ADDENDUM NO. 1 DATED 10/20/2015 ADDENDUM NO. DATED
 ADDENDUM NO. DATED ADDENDUM NO. DATED

Number	Description
1	Revised TOC; Bid Items; Plan Sheet Nos. 2, 6-9, 8001, 8002, & 8037; Amendment EBS Download Required.

PROJECT: STP-0008-04(046) / 102127301 - Holmes

Construction necessary to create a Railroad Overpass on US 49E at Bee Lake, known as Federal Aid Project No. STP-0008-04(046) / 102127301 in Holmes County.

MISSISSIPPI DEPARTMENT OF TRANSPORTATION	
TYPICAL SECTION MAIN FACILITY	
PROJ. NO.: STP-0008-04(046)	
COUNTY: HOLMES	
10/14/15	FILENAME: TYPSEC.DGN
DESIGN TEAM	BROWN
CHECKED	DATE
MISSISSIPPI DEPARTMENT OF TRANSPORTATION	
METRIC	
WORKING NUMBER	
TS-1	
SHEET NUMBER	
6

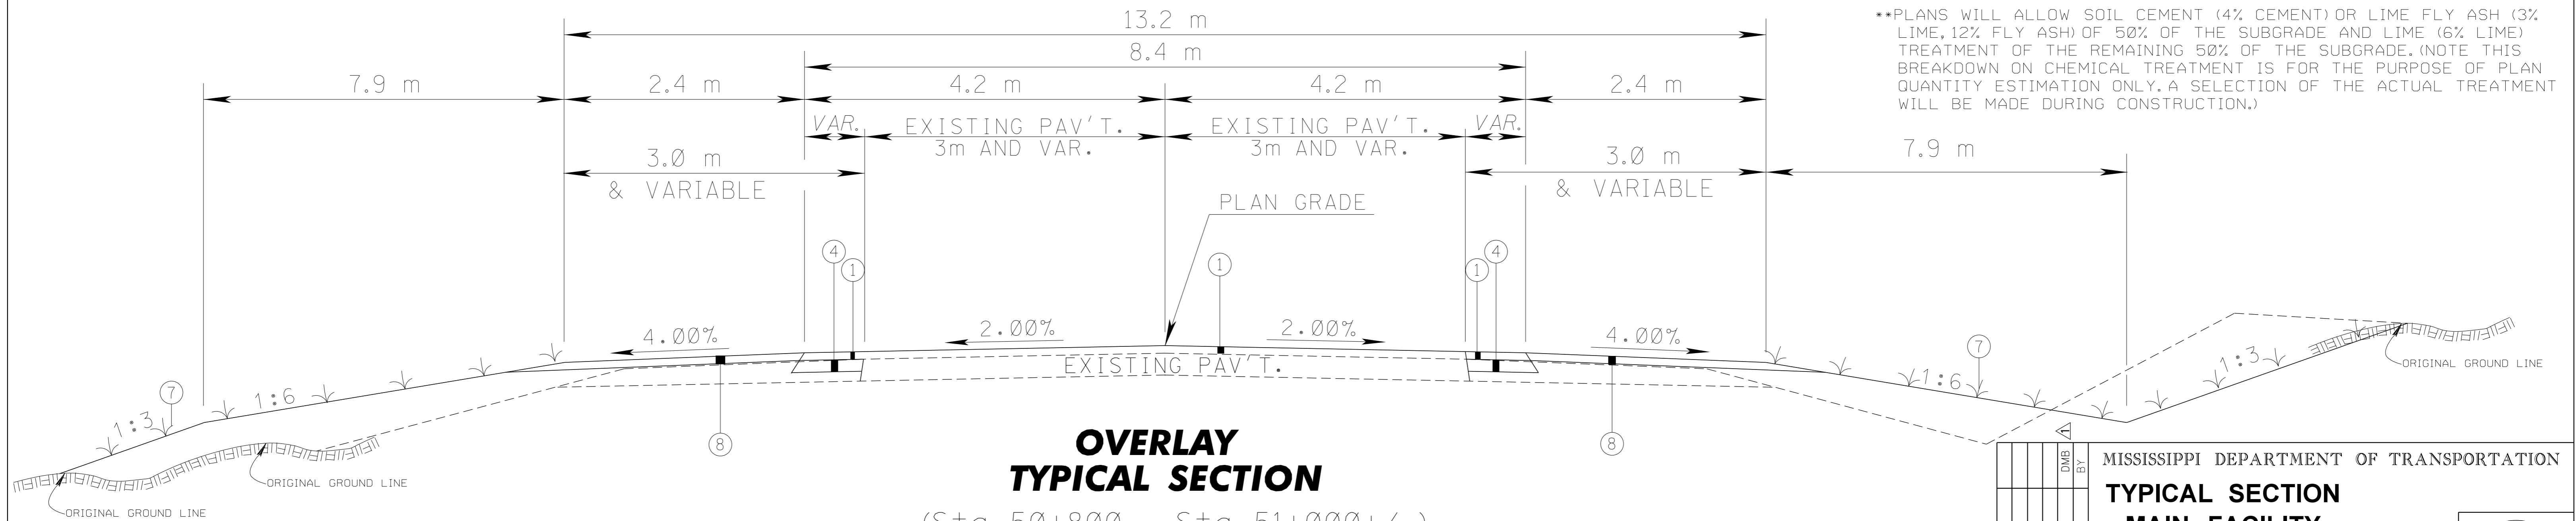
- ④ 75 mm 19-mm, MT ASPHALT MIX TRENCH WIDENING (1 @ 75 mm) REQ'D.
 - * ⑤ 150 mm CHEMICALLY TREATED GRANULAR MATERIAL (CLASS 5, GROUP "E") REQ'D. ⚠
 - ⚠ ⑥ 150 mm SHOULDER GRANULAR MATERIAL (CLASS 5, GROUP "E") REQ'D.

- ⑦ INDICATES AREA TO BE TREATED IN ACCORDANCE WITH THE VEGETATION SCHEDULE. SEE WK. SH. NO. VS-1
 - ⑧ 40 mm SHOULDER GRANULAR MATERIAL (CLASS 5, GROUP "E") REQ'D. ⚠

DWB		BY		MISSISSIPPI DEPARTMENT OF TRANSPORTATION	
REVISED NOTE		REVISION		TYPICAL SECTIONS	
				LOCAL ROAD	
				@ STA. 52+425.000	
				PROJ.NO. STP-0008-04(046)	
				COUNTY: HOLMES	
10/14/15		DATE		WORKING NUMBER	
		FILENAME: TYPSECA.DGN		TS-2	
		DESIGN TEAM BROWN CHECKED DATE		SHEET NUMBER	
				7

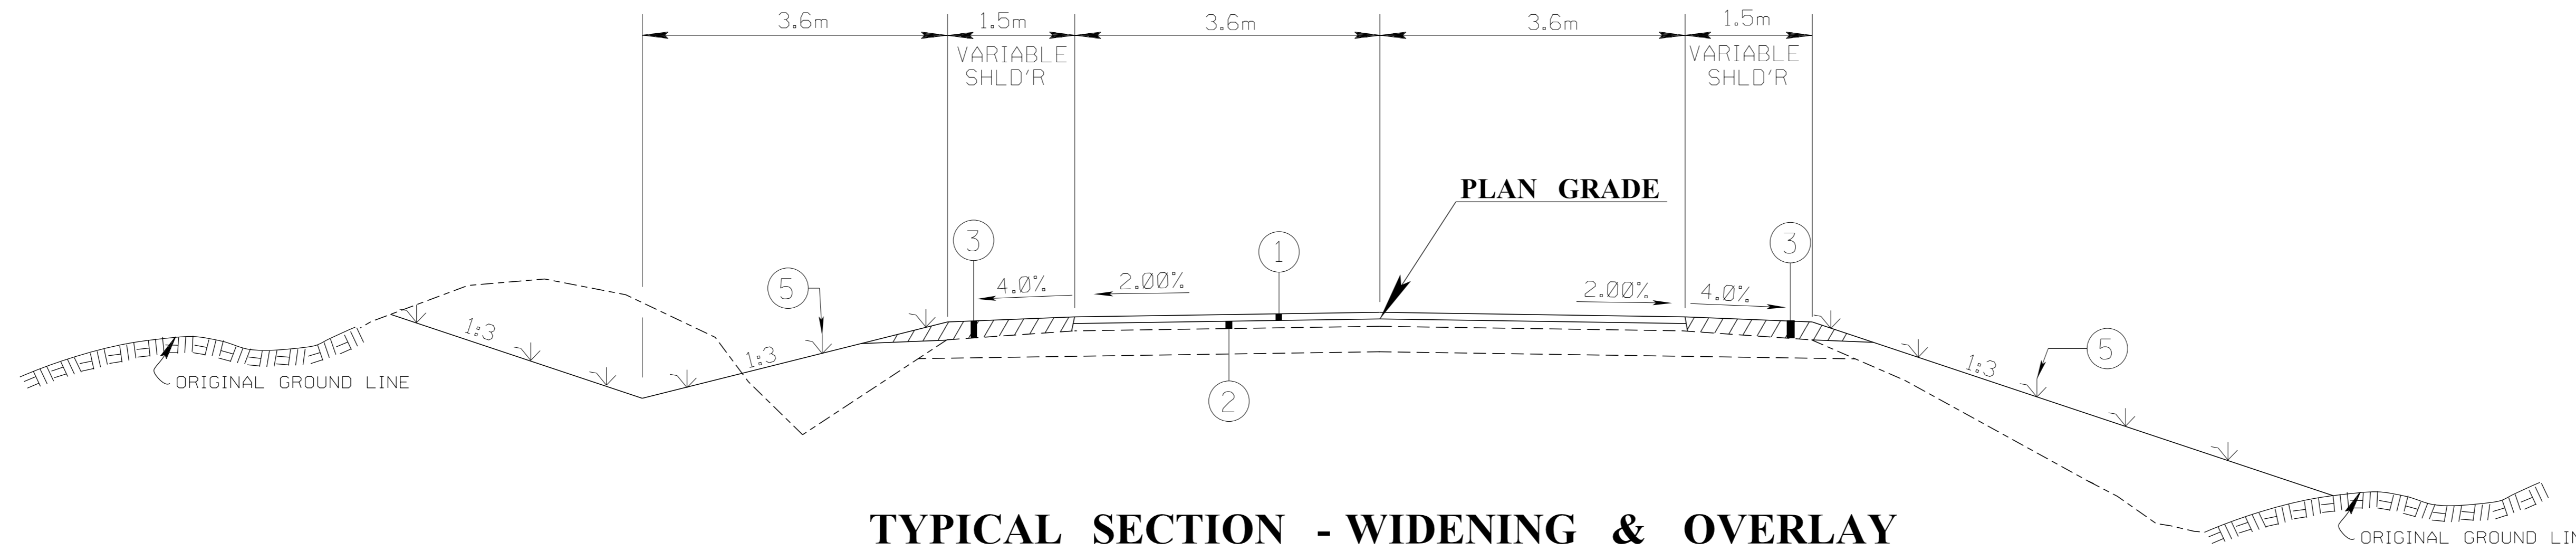
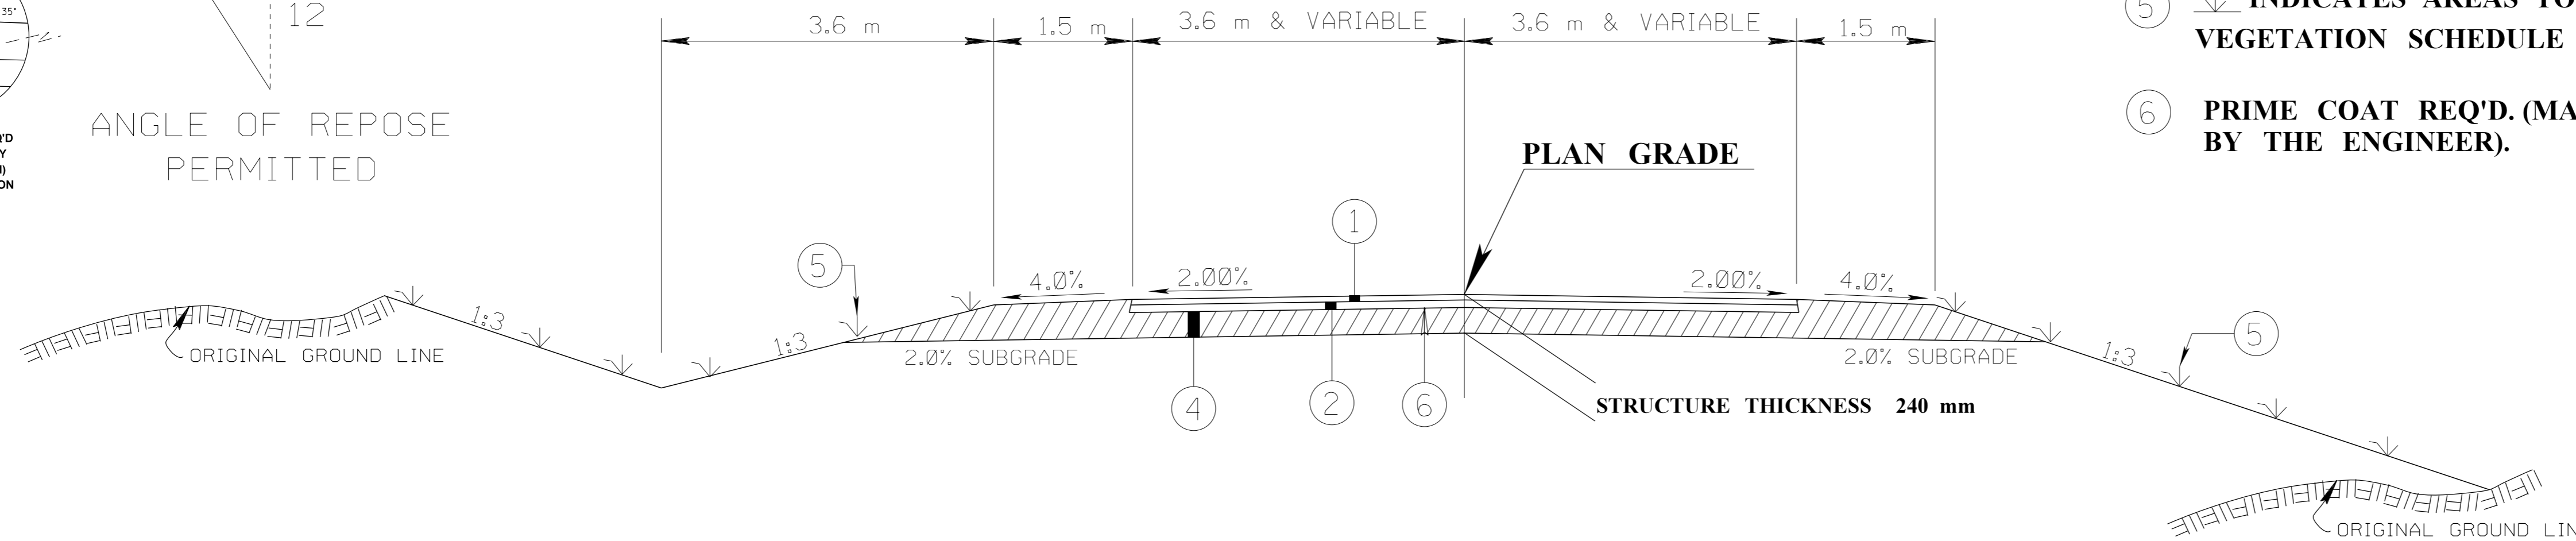
- ① 40 mm 9.5-mm, MT, ASPHALT MIX (1 @ 40 mm) REQ'D.
- ② 50 mm 12.5-mm, MT, ASPHALT MIX (1 @ 50mm) REQ'D.
- ③ 90 mm SHOULDER GRANULAR MATERIAL (CLASS 5, GROUP "E") REQ'D. Δ
- ④ 150 mm GRANULAR MATERIAL (CLASS 5, GROUP "E") REQ'D. Δ
- ⑤ ∇ INDICATES AREAS TO BE TREATED IN ACCORDANCE WITH THE VEGETATION SCHEDULE (SEE WK. SH. NO. VS-1)
- ⑥ PRIME COAT REQ'D. (MAY BE DELETED AS DIRECTED BY THE ENGINEER).
